Annotated Agenda Addendum – 2a – Case NM0197- rev

UNITED NATIONS FRAMEWORK CONVENTION ON CLIMATE CHANGE

NM0197-rev: Power saving through replacement by energy efficient chillers

NM0212 and NM0222: Conversion of SF6 to the Alternative Cover Gas in Magnesium Production

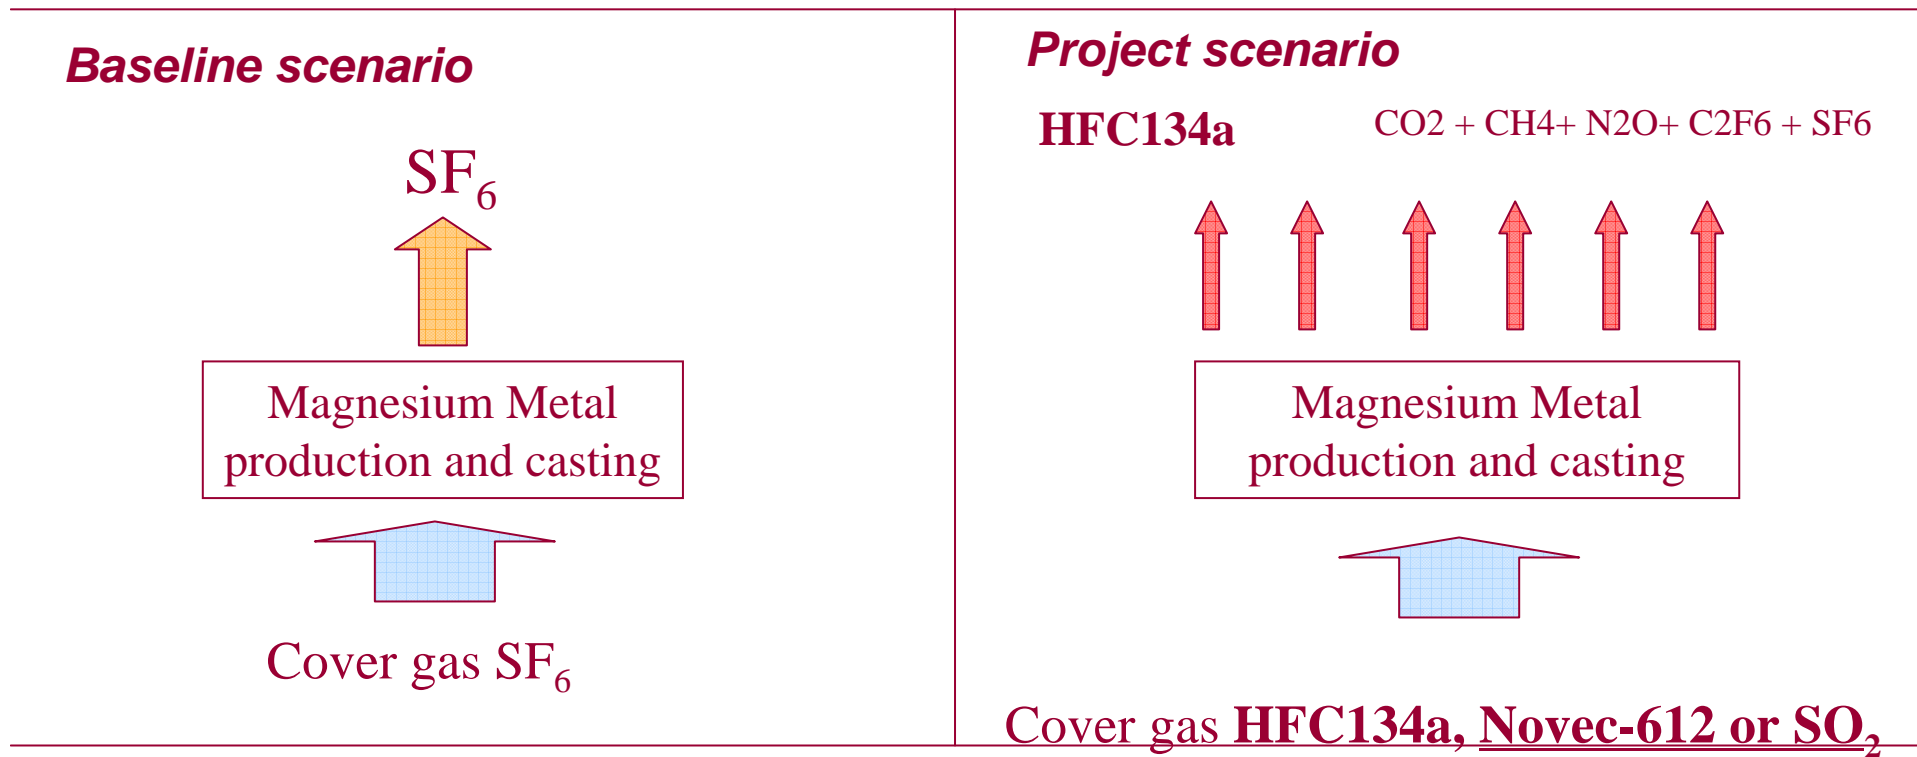
Issue: To allow use of lean-SO₂ as cover gas in Project activity

1. SO₂ technology has been in use for 5-7 years in Europe as SF₆ use is banned in Europe
2. SO₂ was used before SF₆ was introduced in industry.
3. SO₂ in Europe should comply with the regulations of concentration less than 2 ppm.
4. To meet the environmental regulation the “dilute SO₂” has sophisticated delivery systems and also needs instruments in working area to deduct the SO₂ concentration.
5. Die casting may have an exhaust system or may not have one.

NM0212: To allow use of NOVEC-612

- **Novec-612** is a fluorinated ketone, and IPCC does not provide a GWP value
- Three reference provide an approximately the same as CO₂ (i.e., equal to 1)

The draft methodology as proposed is applicable:

- Only “**dilute SO₂**” technology (defined in the methodology) and
- An associated SO₂ **exhausting and abatement system** is installed; and
- Local regulations in the host country regarding SO₂ emissions in the exhausting system should be complied with. If such regulations are not in place, the following value should be taken into account as a cap limit of SO₂ concentration in the exhausting system – 1470 mg/m³ (dry basis, 273 K, 101,325 kPa at an oxygen concentration of 6 %(v/v).

NM0227

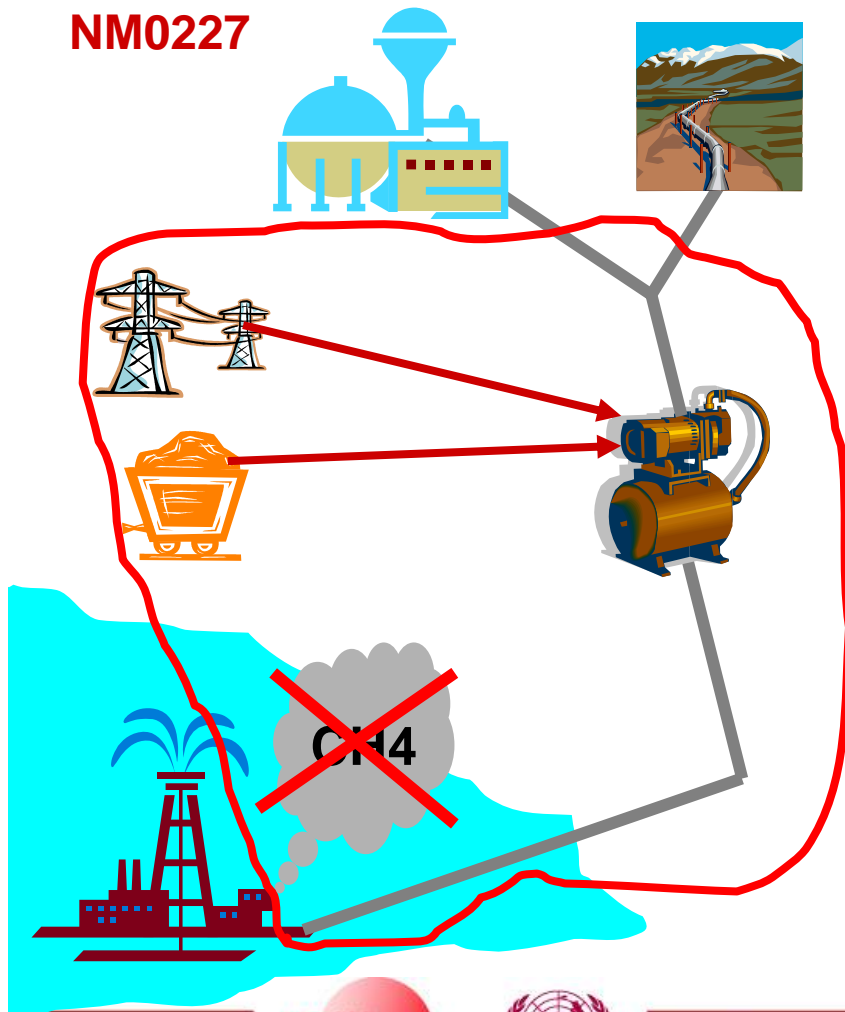
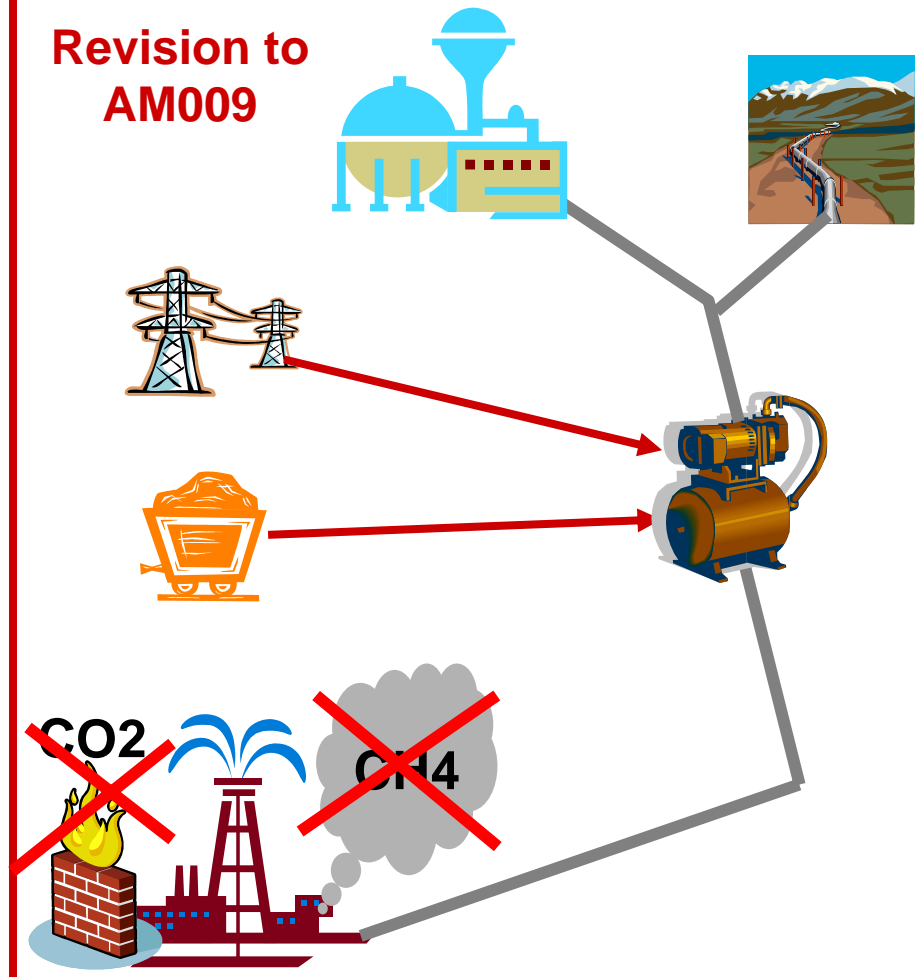
Revision of AM0009 to integrate NM0227

Guidance from the Board is requested:

▶ **Option 1.**

New baseline scenario: venting

Baseline emissions:

$(\text{CH}_4 \text{ from venting}) \cdot (1-R) + (\text{CO}_2 \text{ from flaring}) \cdot R$

▶ **Option 2.**

New baseline scenario: venting

Baseline emissions: CO2 from flaring

NM0231: Waste heat utilization for charge pre-heating in sponge iron manufacturing process at HKMPL, India

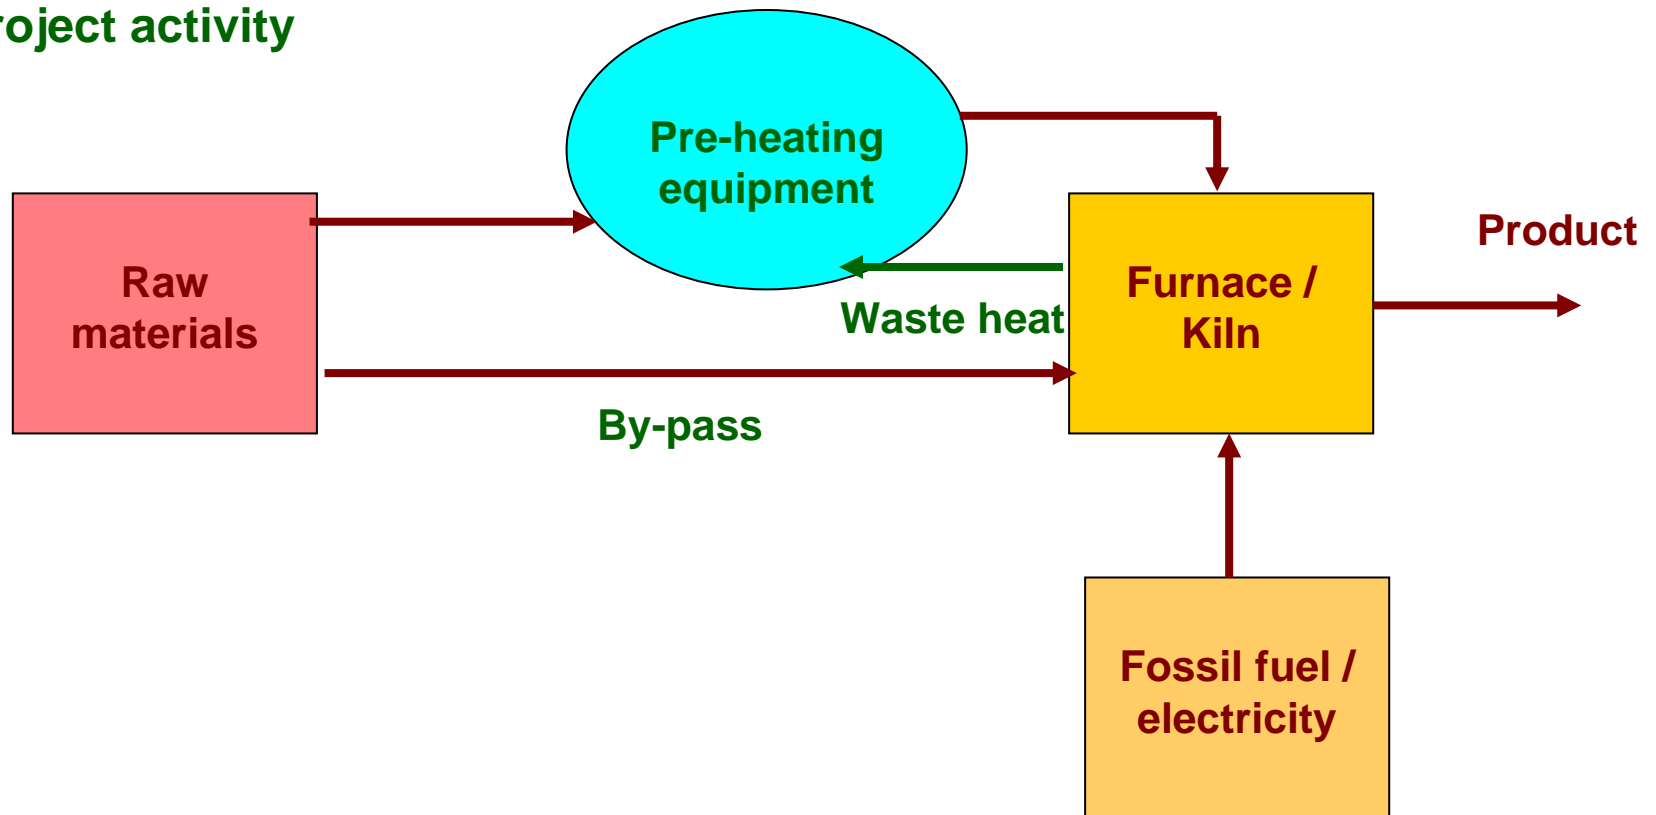
MP questioned the accuracy of estimation of baseline emissions in the case of Greenfield projects and requested secretariat to consult experts regarding a possible impact of pre-heater installation on the design of a kiln/furnace

Guidance from the Board is requested:

- ▶ **Option 1. Applicable to Existing facilities and Greenfield facilities**
- ▶ **Option 2. Applicable to Existing facilities only**

- ▶ Pre-heater is a separate piece of equipment
- ▶ Pre-heater does not affect the design of kiln/furnace
- ▶ Increase in production output

NM0233: Palm Methyl Ester – Biodiesel Fuel (PME-BDF) production and use for transportation in Thailand

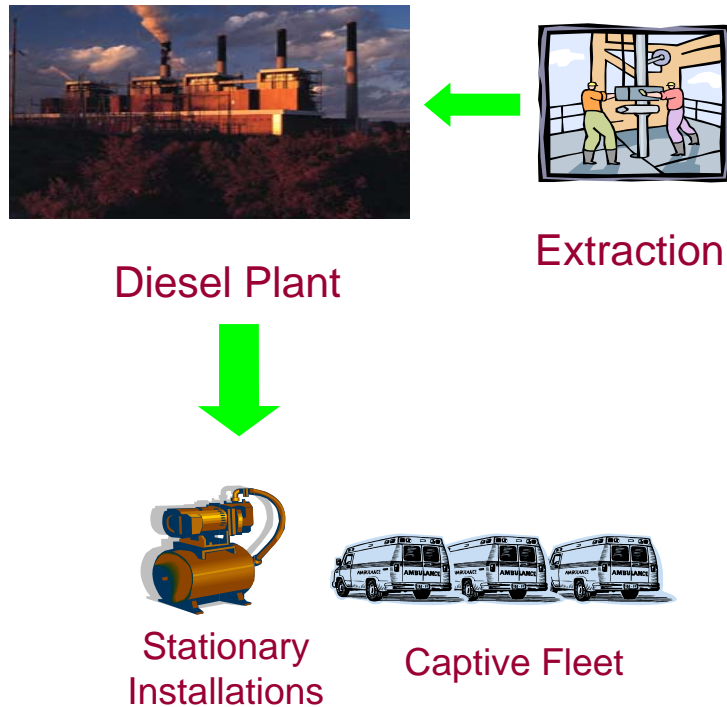
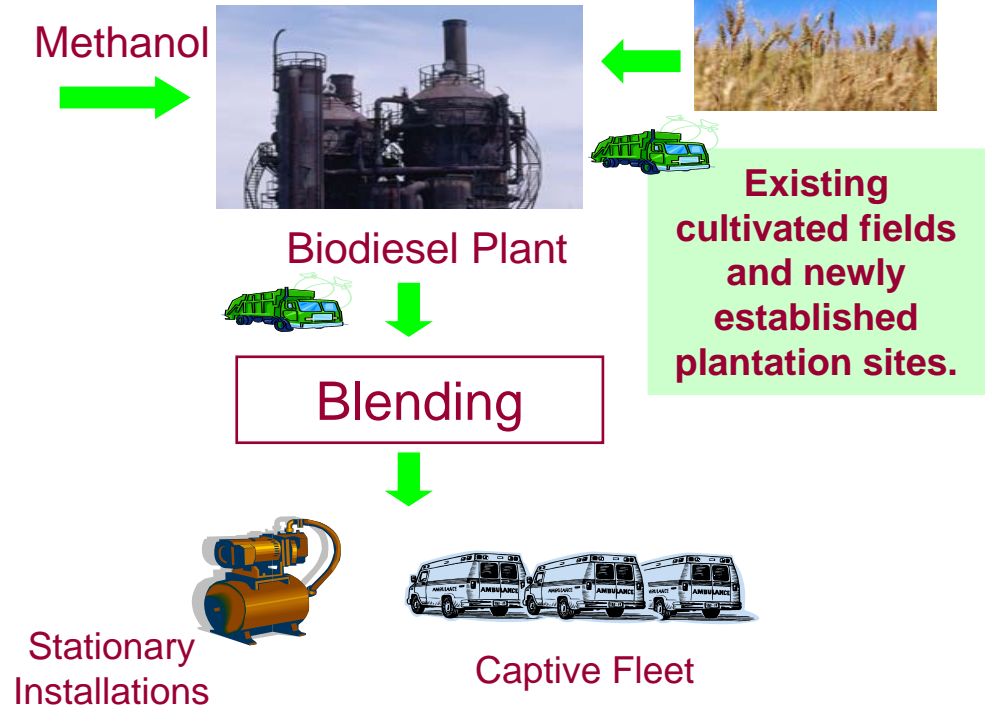
The project activity can lead to **shift of pre-project activities** outside the project boundary, that will be accounted as leakage for indirect land use change. The Meth Panel notes that it has **not concluded** its work on how to address the shift of pre-project activities. Furthermore, the default approach taken in NM0233 to estimate the leakage due to conversion of land to crop land, based on area of conversion runs counter to EB decision (EB24 annex 13) on NM0082rev which considers such an approach as **flawed though conservative**.
